ADDENDUM No. 2

PROJECT: MOORE COUNTY AIRPORT
2024 AIRPORT EXPANSION
DUMAS, TEXAS
TxDOT CSJ NO. 2504DUMAS

DATE: April 16, 2025

CONCRETE DETAILS

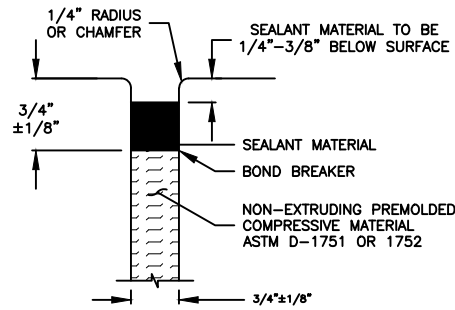
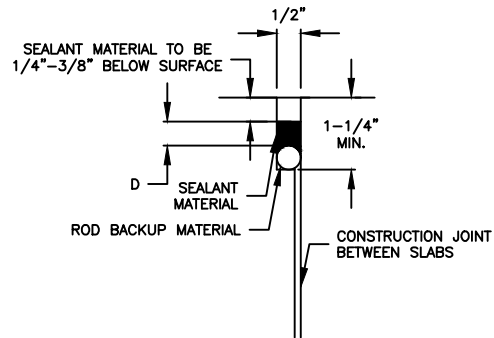
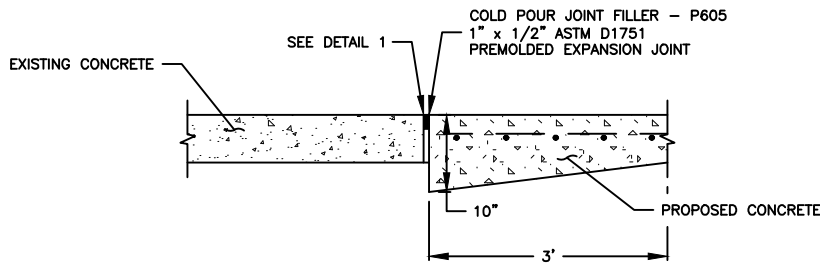
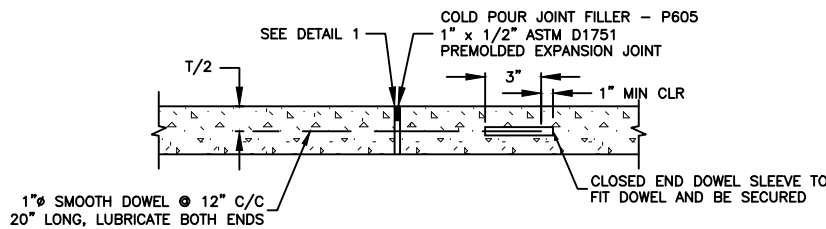
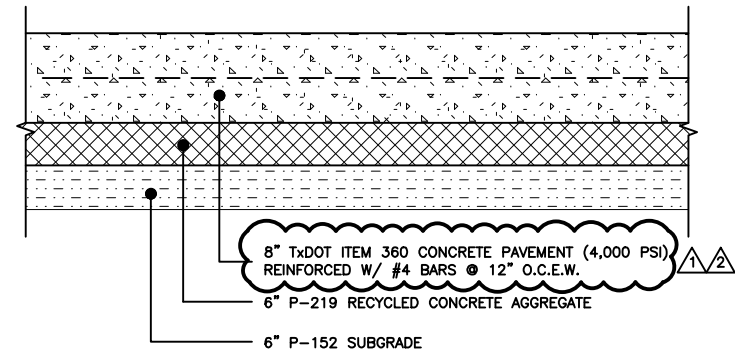
Sheet 15 of 35 – CONCRETE DETAILS

Remove and replace plan sheet with the attached drawing.

- a. The intent is to follow the TxDOT specifications for concrete. A revised Bid Form will be issued addressing the inconsistency.
- 5) What joint detail are you wanting us to use for sealing the "Joints Sealants for Pavements – HMAC"? I see details for the concrete joints on Sheet 15, but not for the HMAC joints.

- a. Yes, #4 @12" OCEW

HMAC DETAILS

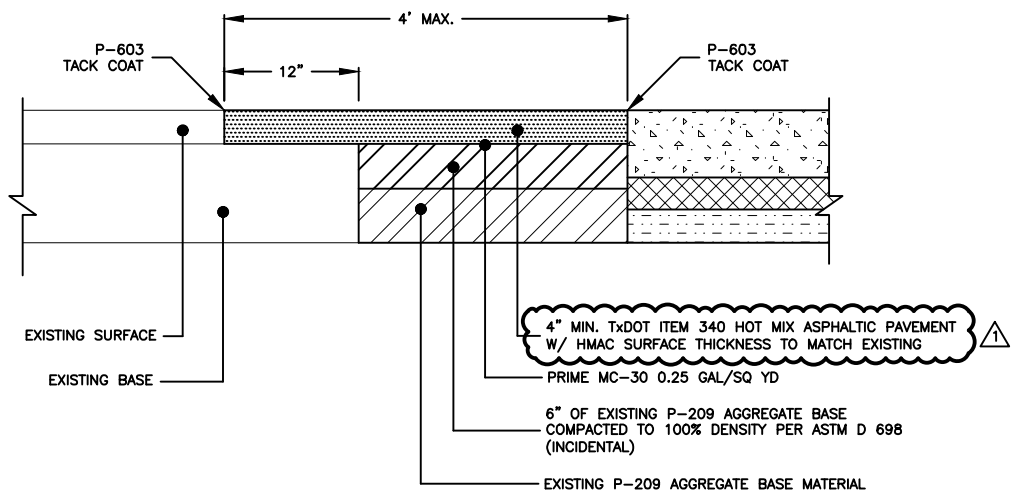
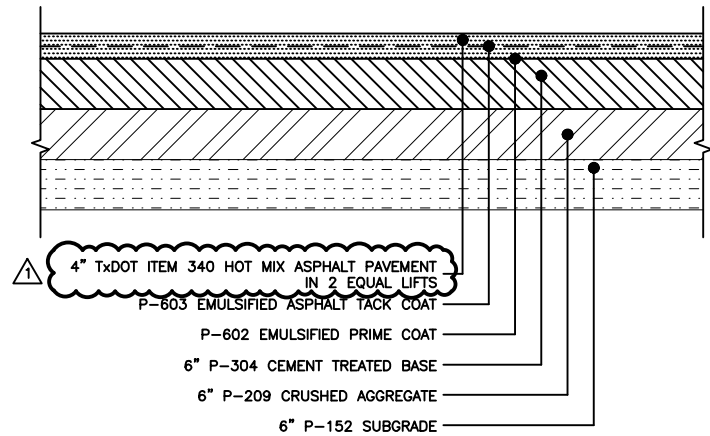
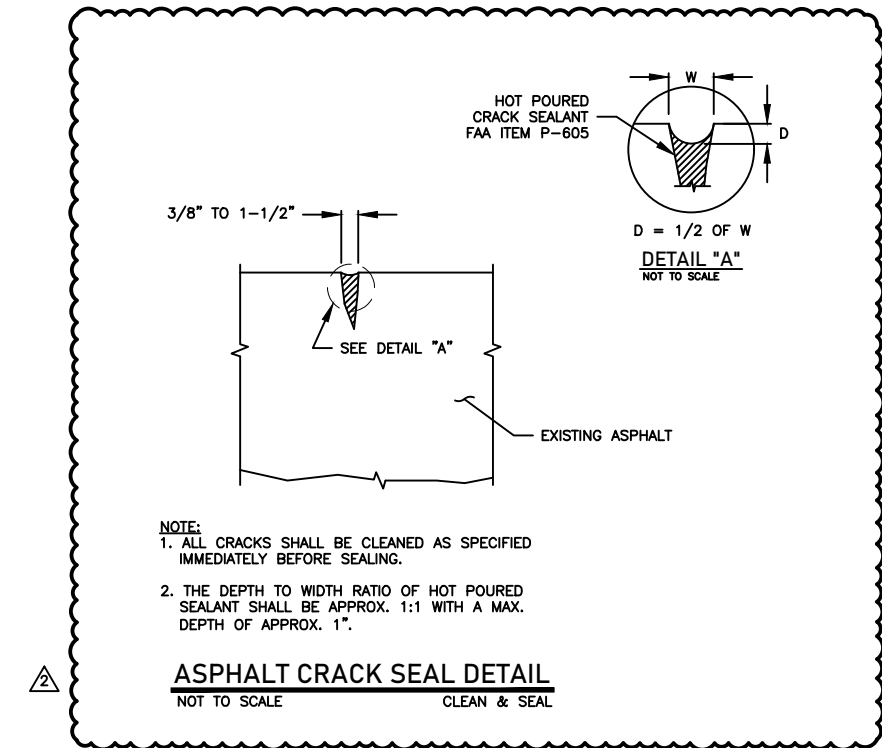
Sheet 16 of 35 – HMAC DETAILS

Remove and replace plan sheet with the attached drawing.

- a. A HMAC joint sealant detail will be included in Addendum No. 2.
- 6) Do you want us to use the same rebar size and spacing for both concrete apron and the low water crossings?
